ATB 00321 (1412)

Third Row Seat Cup Holder Gets Warm

AFFECTED VEHICLES

Year	Model	Trim	VIN Range
2011–15	Odyssey	ALL	ALL

5. Remove the rear (right) side trim panel.

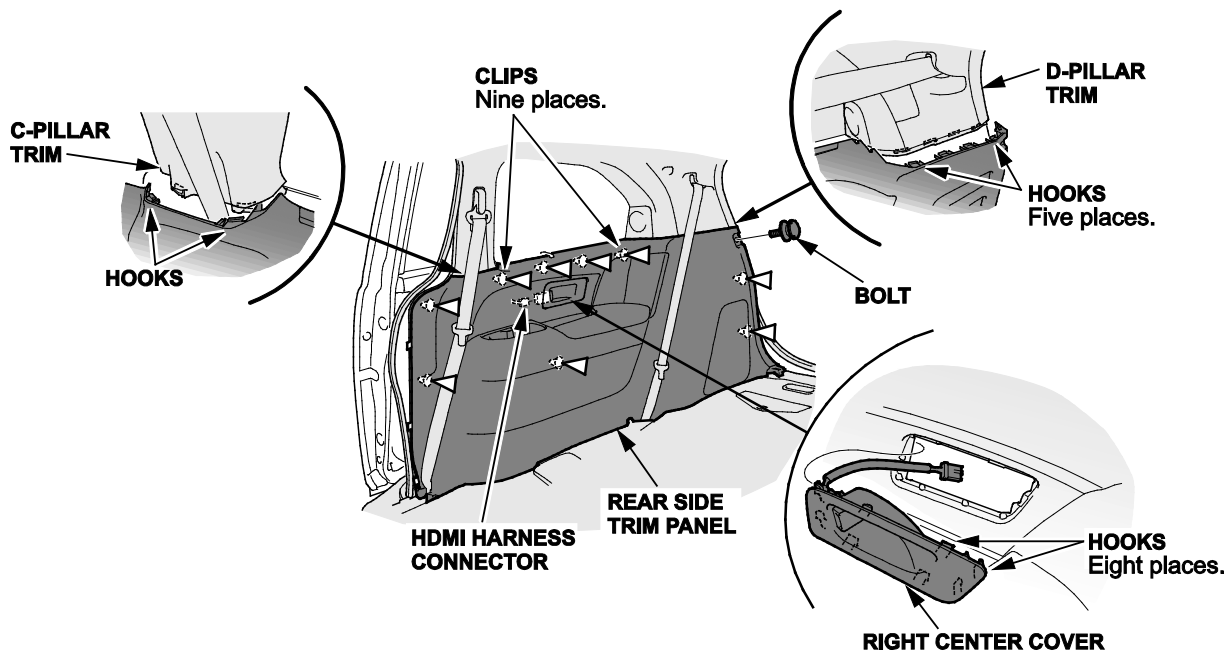
The rear (right) side trim panel does not have enough insulation where the HVAC system components are located.

Replace the rear (right) side trim panel.

6. If necessary, install the right center cover.
7. Install the new rear right side trim panel.
8. Reinstall the rear trim panel.
9. Reinstall the weatherstrip around the tailgate and sliding door.
10. Reinstall the right side sliding door trim.
